# CABINET MEMBER FOR ENVIRONMENT – 12 SEPTEMBER 2019

## RADLEY, KENNINGTON ROAD - PROPOSED TRAFFIC CALMING MEASURES & PUFFIN CROSSING

#### **Report by Director of Community Operations, Communities**

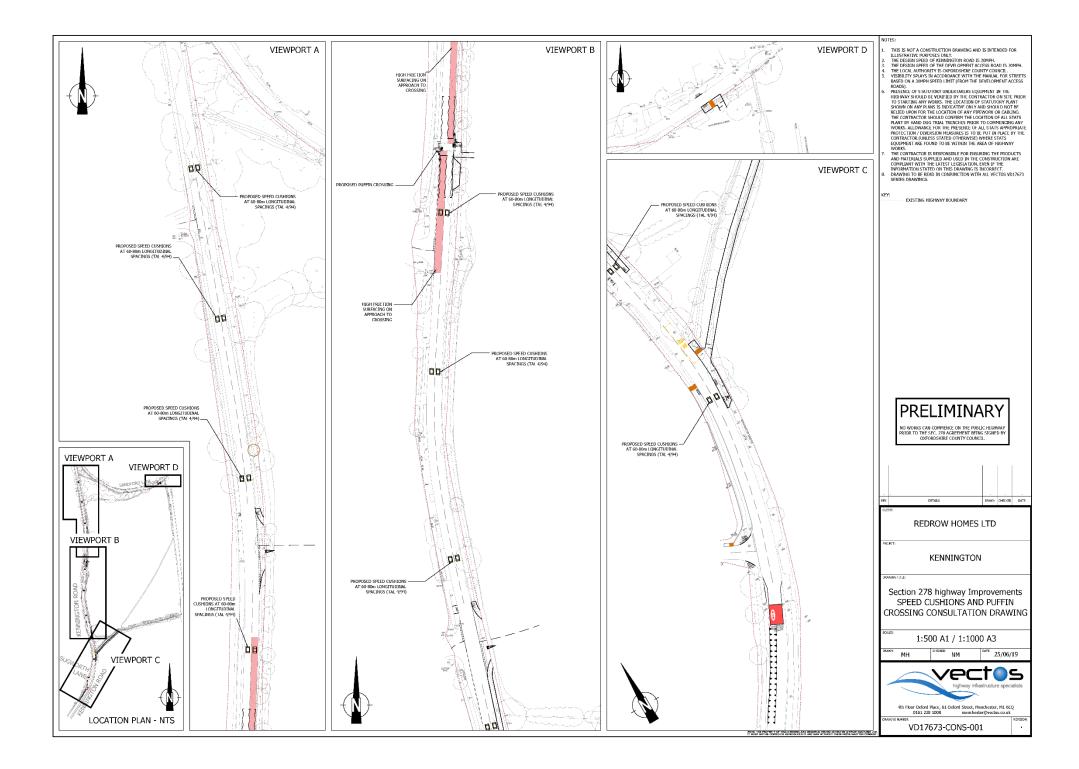
- 9. Three objections were received from members of the public in respect of the proposed speed cushions on the grounds of nuisance and damage to vehicles (particularly emergency service vehicles), the risk that drivers would speed up elsewhere and also use other less suitable routes such as Sugworth Lane. Concerns were also expressed that the speed cushions would increase vehicle emissions and noise and prove to be a maintenance liability. One of these objections also related to the proposed puffin crossing on the grounds of lack of need, though the crossing was supported by the other two members of the public objecting to the cushions.

(4) Local Resident, (Radley)	<b>Object</b> – I am in favour of traffic calming measures and the Puffin crossing; however, I am against the speed cushions. There is scientific evidence that shows that speed cushions are harmful to health and environment because drivers emit more particulate emissions as they halt for the speed cushion. Particulate emissions cause lung disease, especially in children and the elderly. This particular section of Kennington Road houses disproportionally many elderly (mobile home parks) and will house many children in the new development. There is also an increase in noise caused by traffic going over speed cushions and potential damage to ambulances, fire vehicles and busses. Instead, traffic islands could be used (with greenery to make it look nicer) or narrowing the road in parts.

(5) Local Resident, (Radley)	<ul> <li>Object – Putting in more traffic calming along Kennington Road, will be a waste of time, and money which could be used elsewhere. Drivers who speed do not care about these objects. Drivers do worry about the damage to their car suspension and about suing the Council.</li> <li>Another crossing is it worth the bother? Anyone who sees the parents taking their children to school will see how little</li> </ul>
	they use the way outside Kennington school. TRAFFIC CALMING ONLY ANGERS DRIVERS MORE SO THEY DRIVE FASTER TO GET PAST THEM. ANOTHER CROSSING WOULD BE WELCOMED.

(6) Local Resident, (Radley)	<b>Object</b> – I support the installation of a puffin crossing across Kennington Road some 45m north of the junction with Pebble Hill to service the new development. I presume there will be a footpath installed to access this from the new development.
	However, I am strongly against the proposal to construct 9 pairs of extended speed cushions (road bumps in plain English) between Sugworth Lane and Sandford Lane. The road through Kennington already has a plethora of speed bumps, creating such a rough ride that people actively avoid the Kennington Road and tend to use Sugworth Lane and either the A34 or the Oxford Road to access the Southern Bypass Road. To extend this mass of speed bumps several hundred metres into Radley will only add to the aversion to use Kennington and divert more traffic along the totally unsuited Sugworth Lane.
	If you do decide to go ahead, could they please be constructed correctly. Those in Kennington are not in the centre of the lane but offset towards the middle of the road. This means that to straddle the bumps correctly drivers are forced towards the centre of the road and if there is a vehicle coming from the opposite direction the risk of collisions is increased. It is quite common to see pieces of broken wing mirrors along the Kennington Road.

An increase in speed bumps is also going to affect emergency vehicles. In particular, the ride for sick and injured people in ambulances will become even more painful.

- 10. In response to the above, it should be noted that the proposed speed cushions are to a bus friendly design and will allow almost all vehicles to pass over them at the 30mph speed limit with minimal if any discomfort and so should not lead to vehicles slowing/accelerating for the features. It is not considered, therefore, that there is a risk of increased emissions or noise or any adverse impact on emergency service vehicles. Similarly, the risk of vehicles diverting to other less suitable routes is considered minimal.

- 11. The puffin crossing is judged to be required given the increased crossing demand likely to arise from the new residential development.
- 12. Five expressions of support were received from members of the public to all the proposals. Two of these respondents also requested speed reduction measures at other locations, including on Sugworth Lane adjacent to Bigwood Park and on Sandy Lane at the access point to the Sustrans Cycle Route 5. These are noted with measures to improve safety at the latter under investigation.
